CLASS RULE CHANGES

International Europe Class

The following amendments to the Class Rules have been approved to be effective 1st March 2002.

5. Sailtrack width

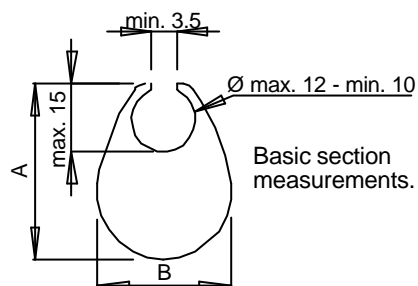
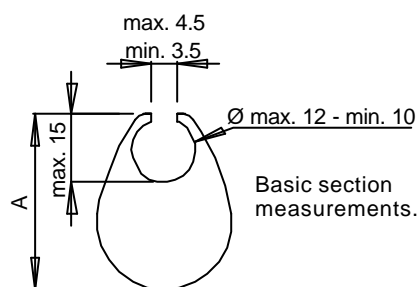
- 1.) Mast Design Specifications - Table of Offsets, figure I: min 3.5 mm
- 2.) Mast Measurement Diagram Sheet 1 of 2

- 3.) Mast Measurement Form Item No. 4b10 (a) Sailtrack opening slot, width min 3.5 – max 4.5 mm

- 1.) Delete Mast Design Specifications - Table of Offsets, figure “I: min 3.5 mm” and enter instead “I: ± 0.5 , 4.0 mm
- 2.)

6. Rudder Fittings

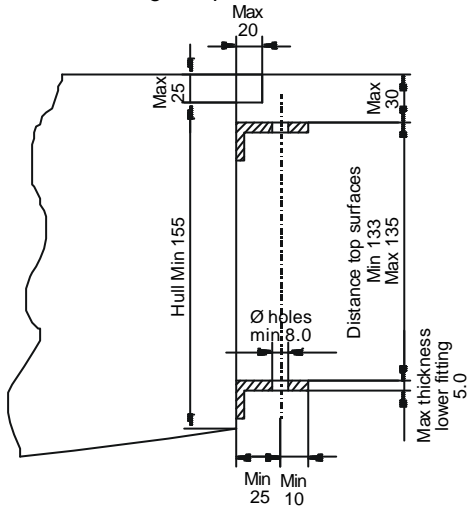
3.4.5 (iv) The fittings to connect the rudder stock to the hull shall be made so that every rudder stock fits every hull. This shall apply for new rudder stocks and boats first measured after 1 March 1998 and all rudder stocks and all boats after 1 March 2000.

Delete “and all rudder stocks and all boats after 1 March 2000”.
